Central Valley Regional Water Quality Control Board
31 January/1 February Board Meeting

Response to Comments
for the
Mountain House Community Services District
Mountain House Wastewater Treatment Plant
Tentative NPDES Permit Renewal
and Tentative Time Schedule Order

Exhibit 6-12, USEPA NPDES Permit Writers' Handbook (EPA-833-K-10-001 September 2010)

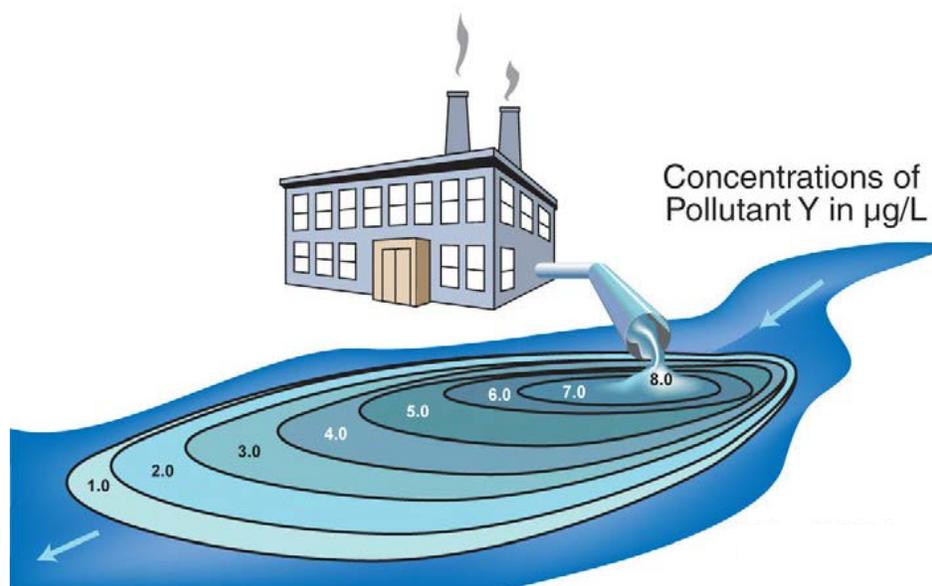
USEPA comments that the permit must impose effluent limitations for iron, manganese, and aluminum. USEPA has three main comments in this item:

- a) The receiving water concentrations exceeded the applicable water quality objectives.
Therefore, it is appropriate to conclude these discharges contribute to an excursion above applicable water quality standards and that reasonable potential exists, even though effluent concentrations for iron, manganese, and aluminum do not exceed the applicable water quality objectives.

- b) It is appropriate for the Regional Board to follow existing State and federal guidance.
The State has not established an alternative procedure for conducting the reasonable potential analysis for non-priority pollutants. Therefore, it is appropriate for the Regional Board to follow USEPA's reasonable potential analysis procedures provided in the Technical Support Document for Water Quality based Toxics Control (TSD). Using the TSD approach results in a finding of reasonable potential for these constituents.

Exhibit 6-12 in the NPDES Permit Writers' Manual (see below) depicts an example of an incompletely-mixed discharge and how the appropriate receiving water concentration may be determined using an incomplete mixing water quality model. USEPA recommends using the in-stream pollutant concentration at the edge of the regulatory mixing zone. In the example, the exhibit shows possible regulatory mixing zones and examples of the pollutant concentrations at the edge of each mixing zone. The proposed Order does not allow mixing zones for aluminum, iron, or manganese. Therefore, the projected constituent concentration at the edge of the regulatory mixing zone would be the projected maximum effluent concentration at the end-of-pipe (i.e., no dilution allowed). In USEPA's example, it would be the receiving water concentration shown as "8.0".

As recommend by the TSD, the projected maximum effluent concentrations were calculated using the TSD's Table 3-1, *Reasonable Potential Multiplying Factors: 99% Confidence Level and 99% Probability Basis*. The projected maximum effluent concentrations for aluminum, iron, and manganese are below the applicable water quality objectives. Therefore, using USEPA's recommended RPA method for incompletely-mixed discharges results in a finding of no reasonable potential.
